Tom Green County

RFB 21-012 Burma Rd. Repair

March 30, 2021

ADDENDUM NO 2: Notice to Bidders

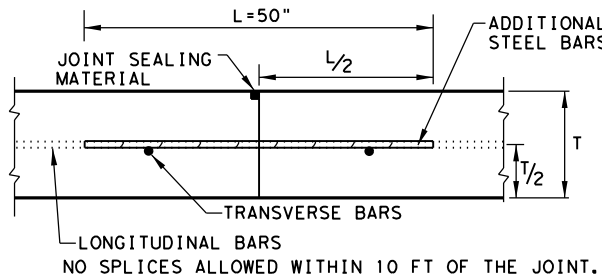
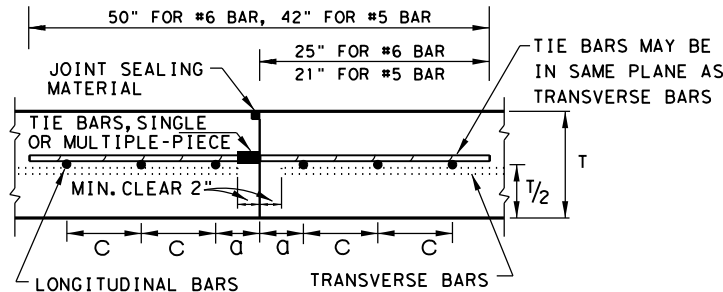
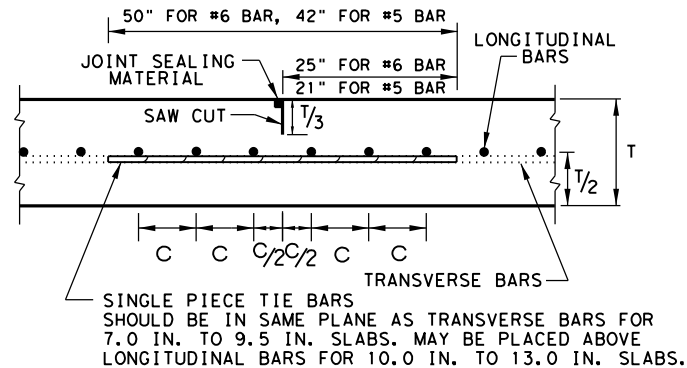
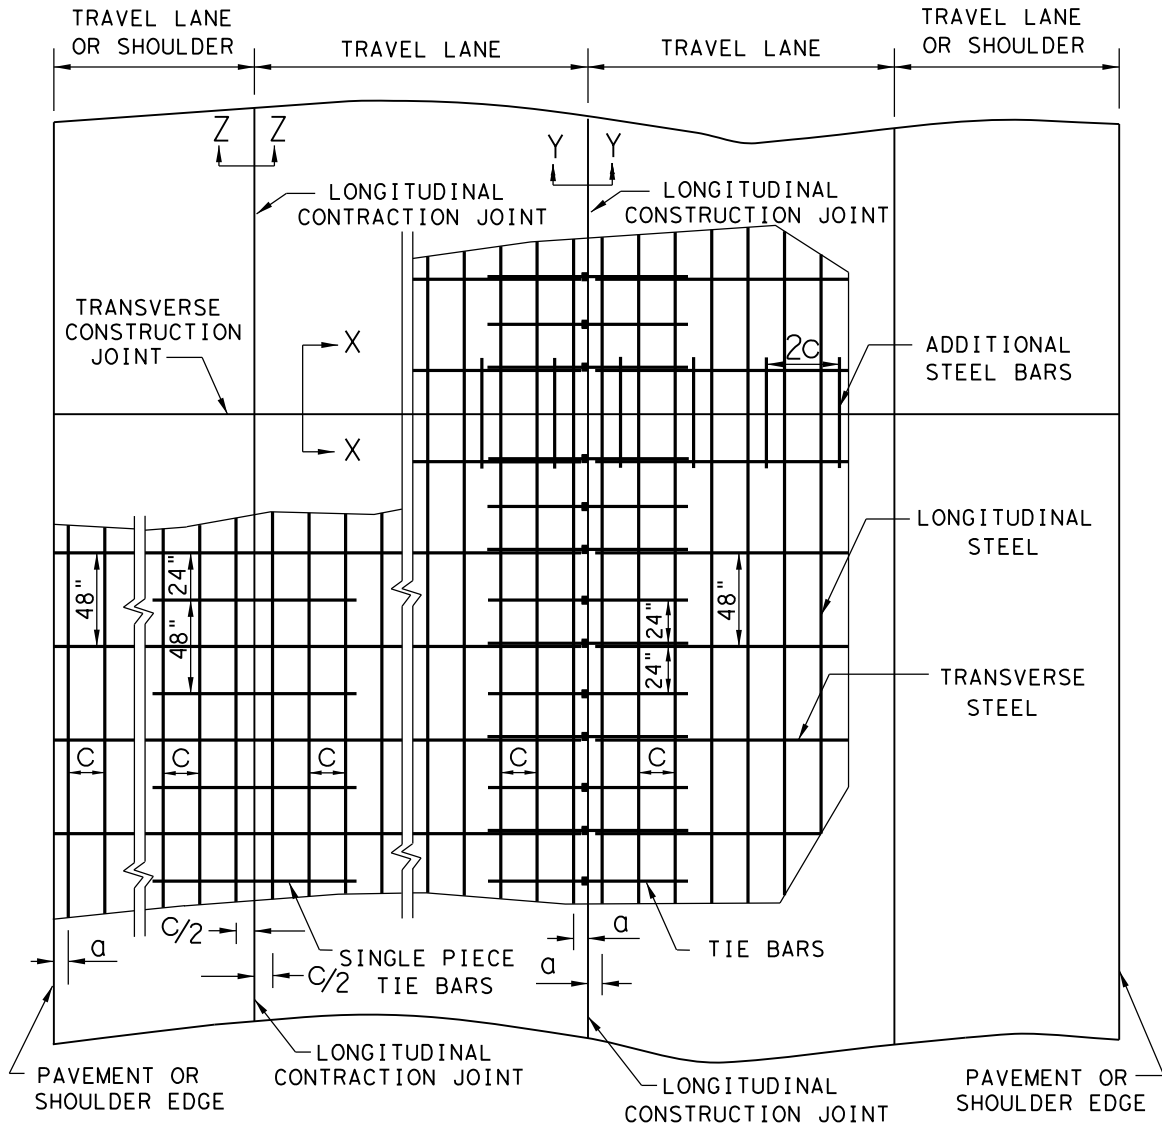
2. Which Item # in the TX DOT Specs. applied to the 8" thick (Fast Track) CRCP-(1)-20 Concrete?

3. What type rebar is required?

TGC Response: Please see specifications sheet below for "Continuously Reinforced Concrete Pavement CRCP (1)-20".

TGC Response: Please see specifications sheet below for "Continuously Reinforced Concrete Pavement CRCP (1)-20".
